**VILLAGE OF GERMANTOWN
N112 W17001 MEQUON ROAD
GERMANTOWN, WI 53022**

MEETING: REGULAR MEETING OF THE VILLAGE BOARD

DATE AND TIME: MONDAY, August 16, 2021 7:00 p.m.

REZONING, CERTIFIED SURVEY MAP (CSM), CONDITIONAL USE PERMIT & SITE PLAN APPLICATIONS

PEG JOB#1262.00A
SHEET 3 OF 7

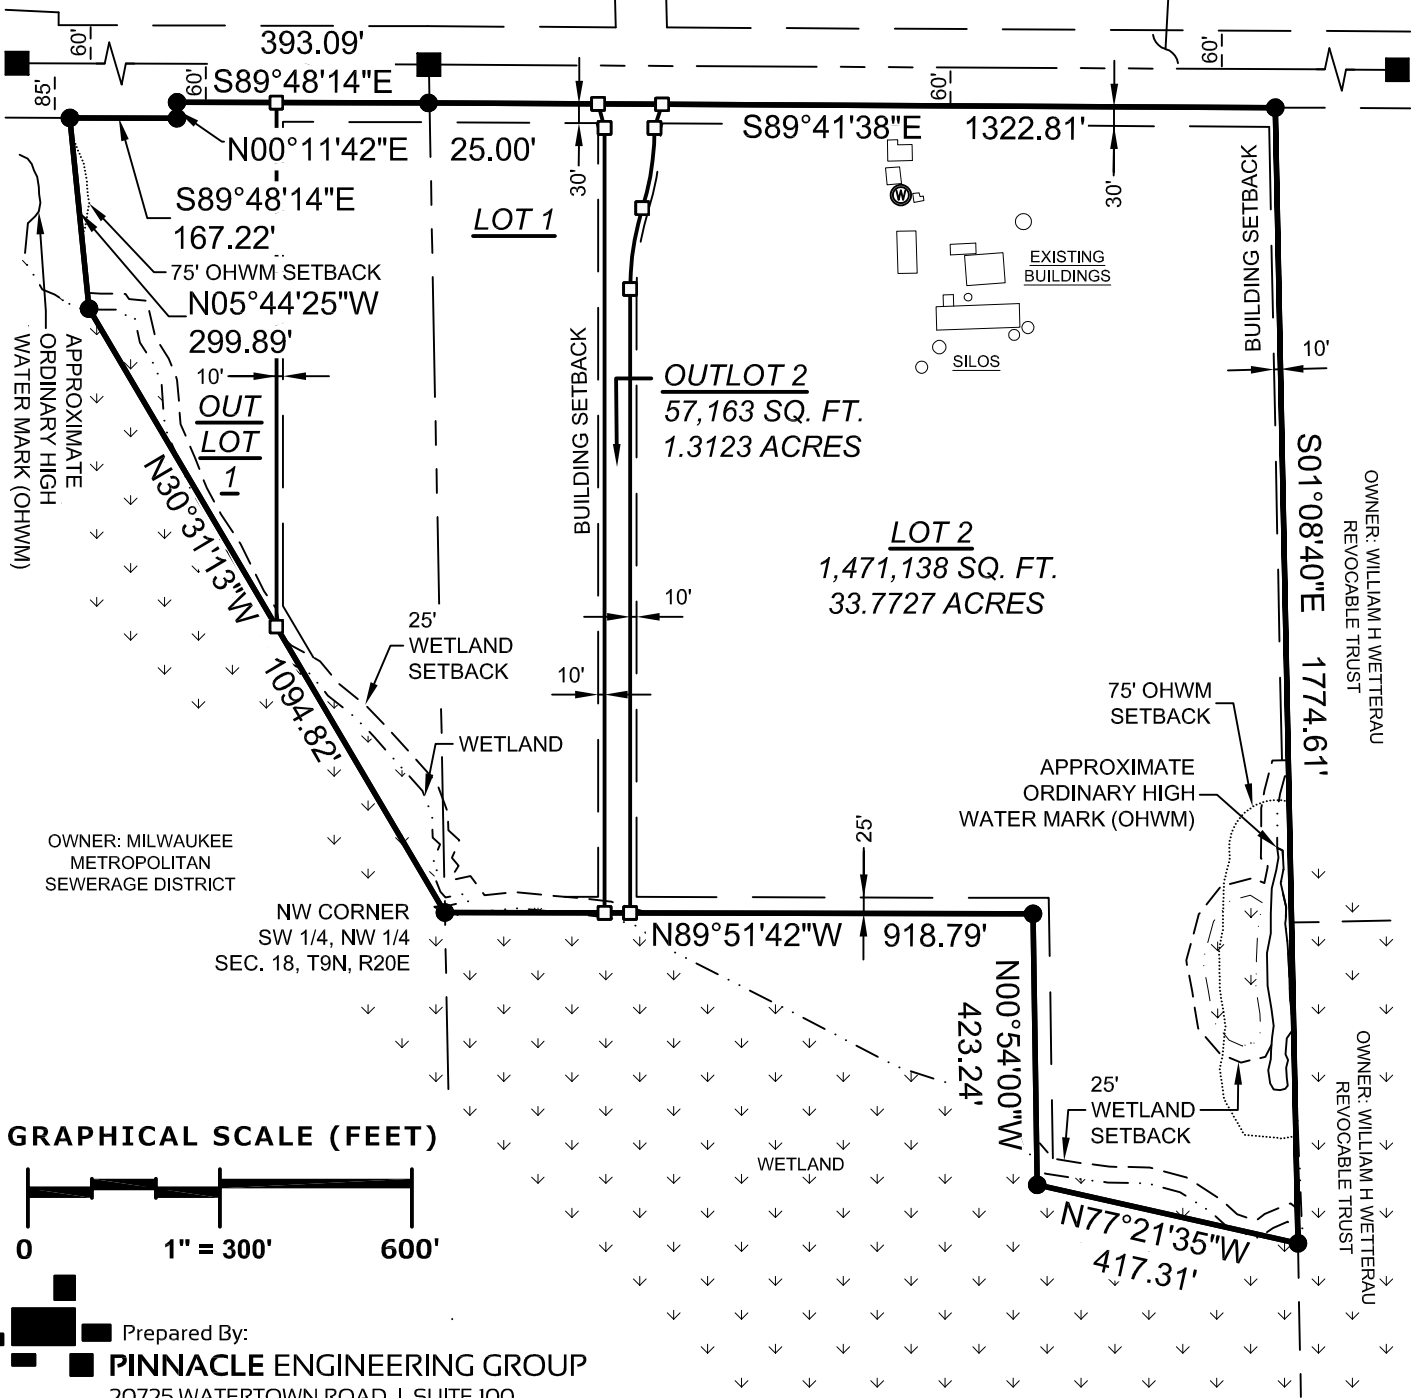
1. Building setback lines are to be mapped and dimensioned. **Setback lines added on Sheet 3 of 7.**
2. Existing structures, well and/or septic cover or vent are to be shown. **Information added on Sheet 3 of 7.**

C-15 Construction Details

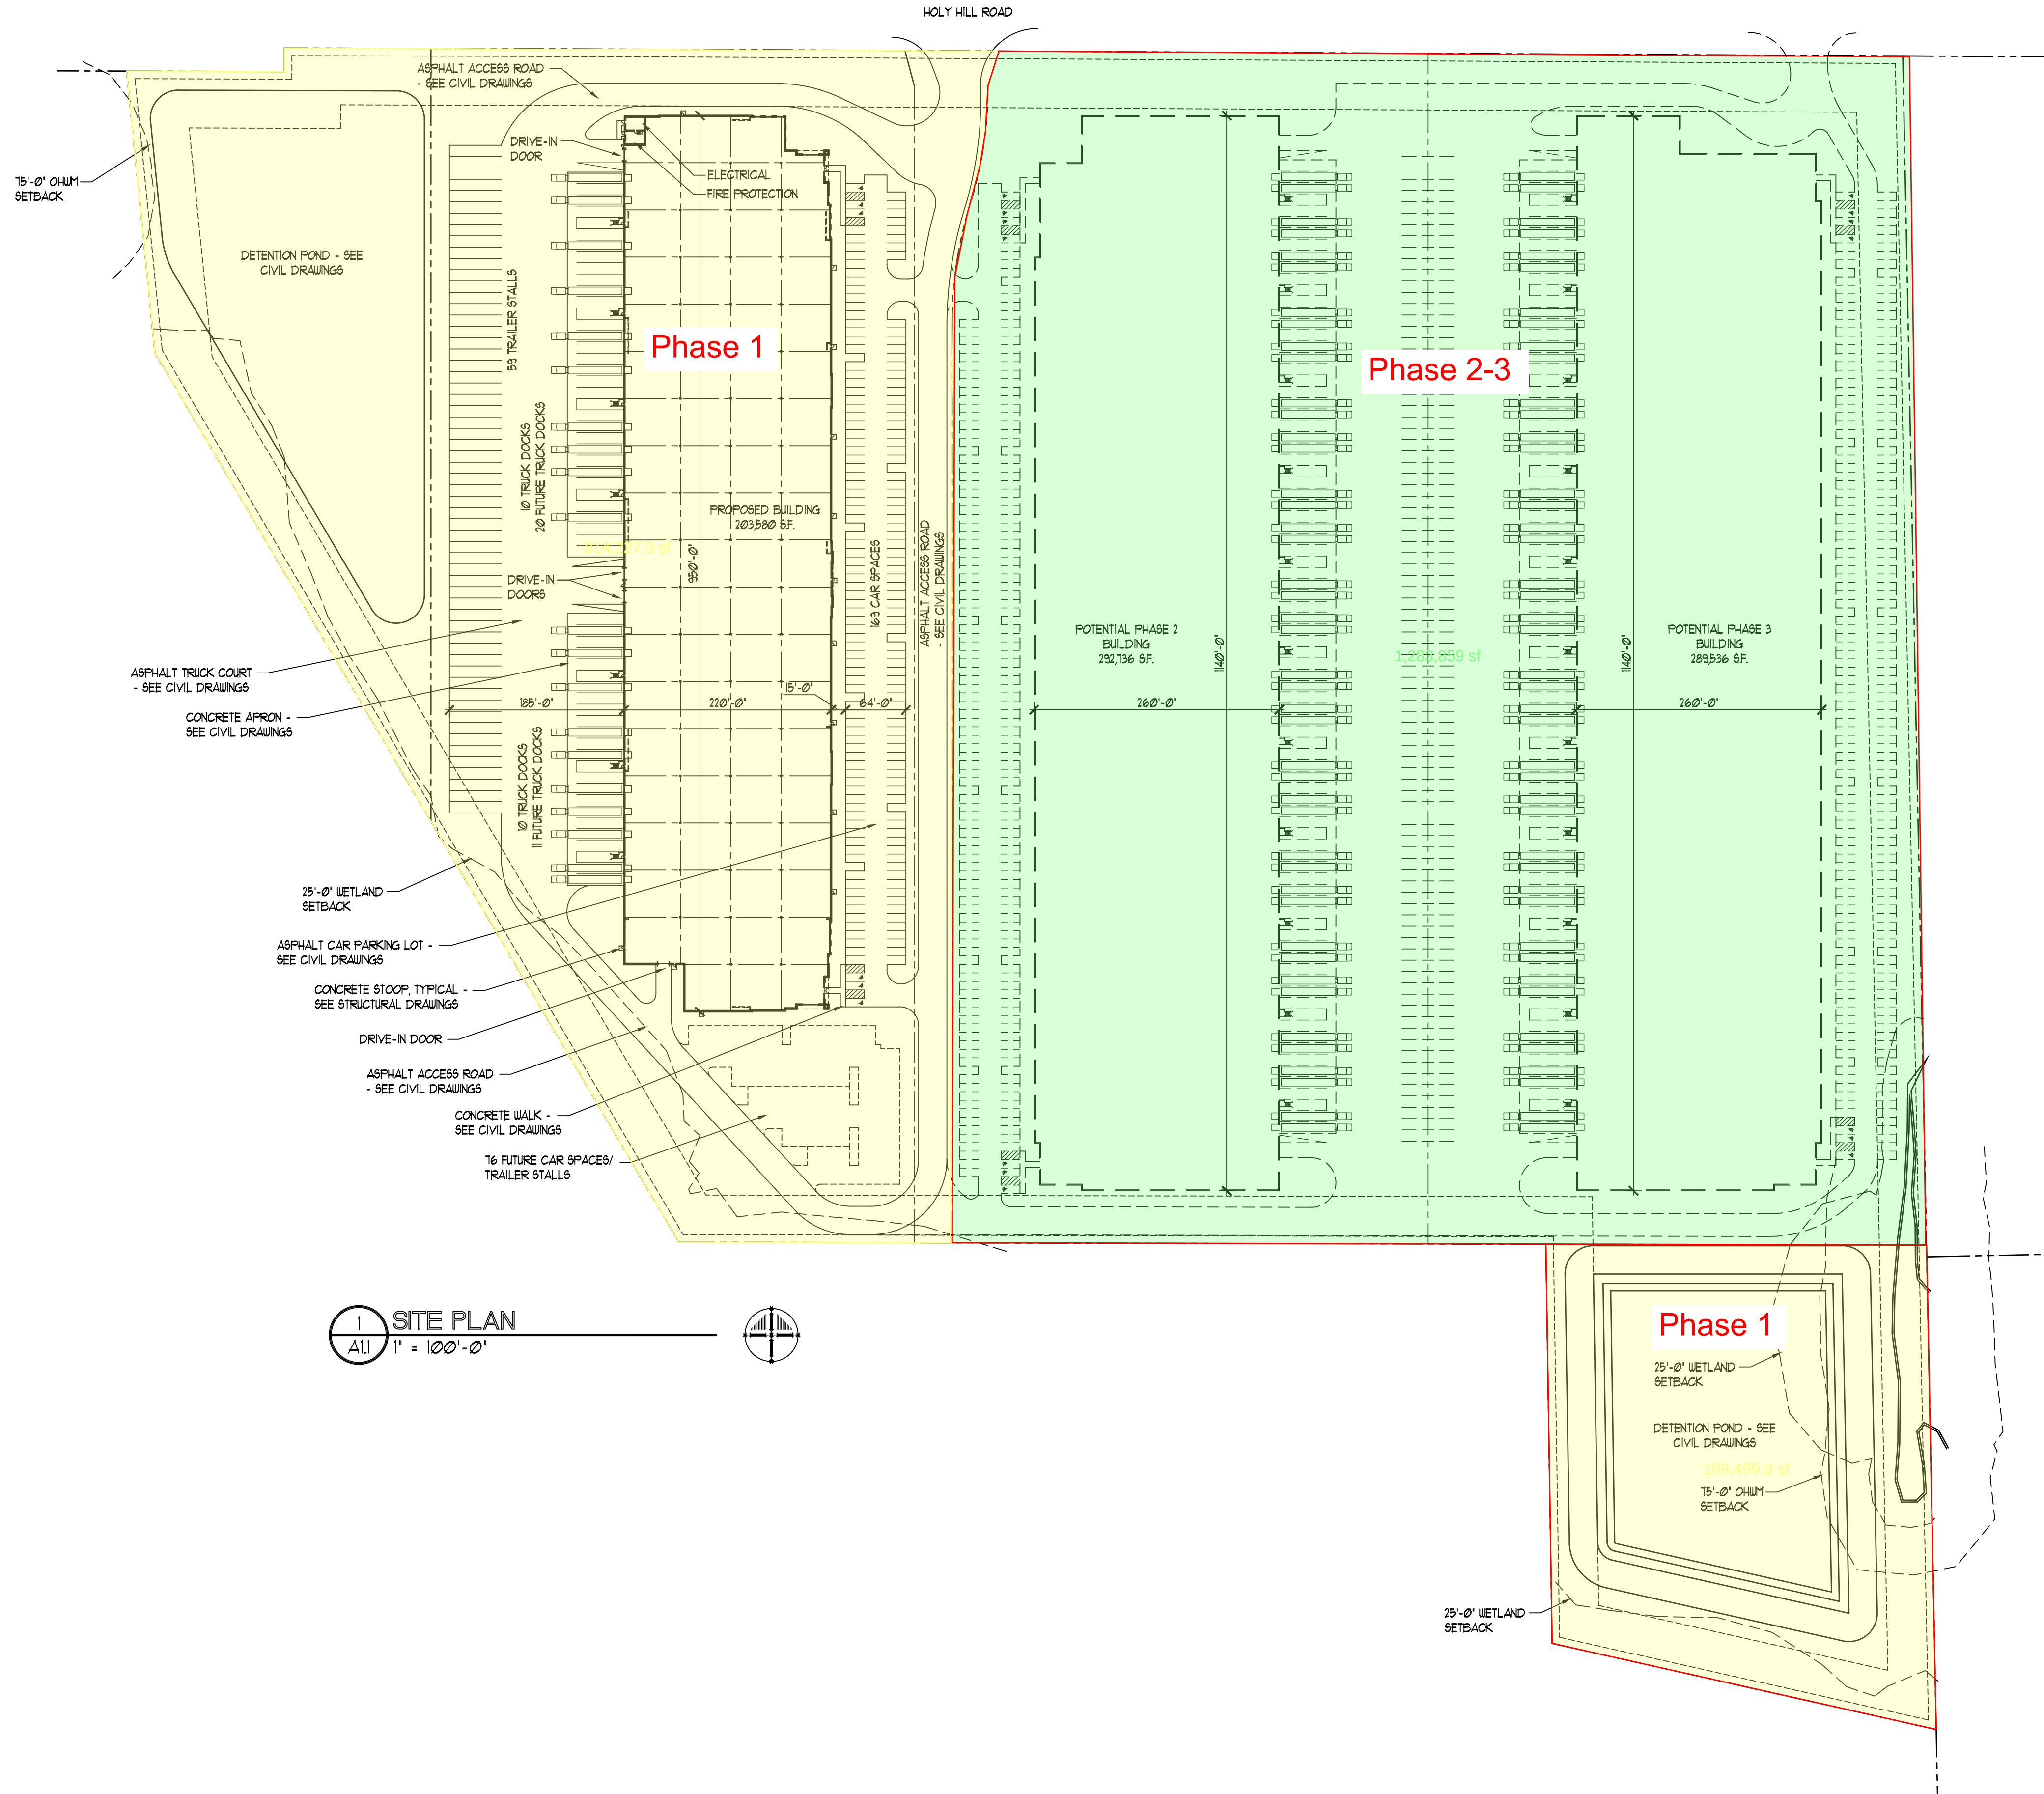
1. Revise basins to have a minimum of 1' of freeboard between the top of the berm and the overflow elevation.
 - † *The detail has been revised to show a 1' of freeboard between the top of berm and the overflow.*
